# Link budget for 40GBASE-CR4 and 100GBASE-CR10

IEEE P802.3ba Task Force Meeting  
New Orleans, LA  
January 2009

## Comment #287: Problem statement

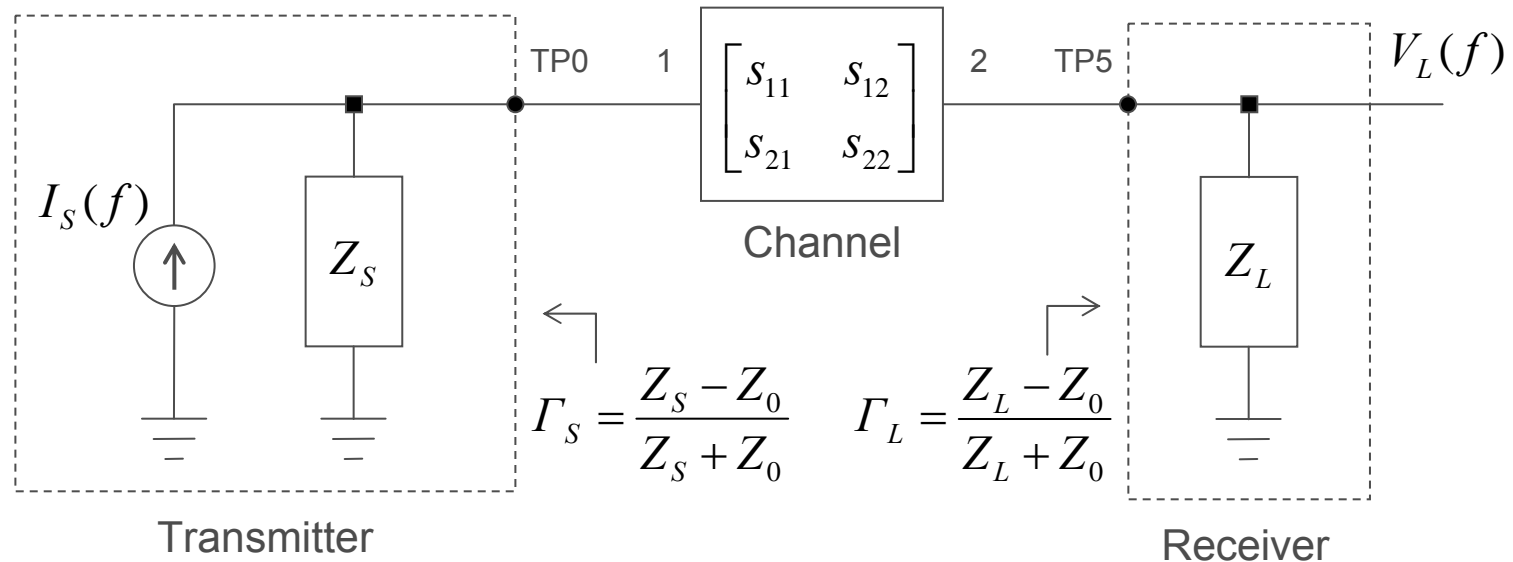
## Observations on channel limits

- Consider a cable assembly with worst case ICR
- The channel ICR limit implies that, when the host printed circuit board (PCB) insertion loss is zero, the channel may have 2.5 dB more noise than the cable assembly
  - In this case, the channel is identical to cable assembly and one would expect it to have the same noise
- As the PCB insertion loss increases, eventually the channel must have a negative contribution to the total noise

- Is it feasible to have a channel that satisfies these constraints with a worst-case cable assembly and worst-case host trace?
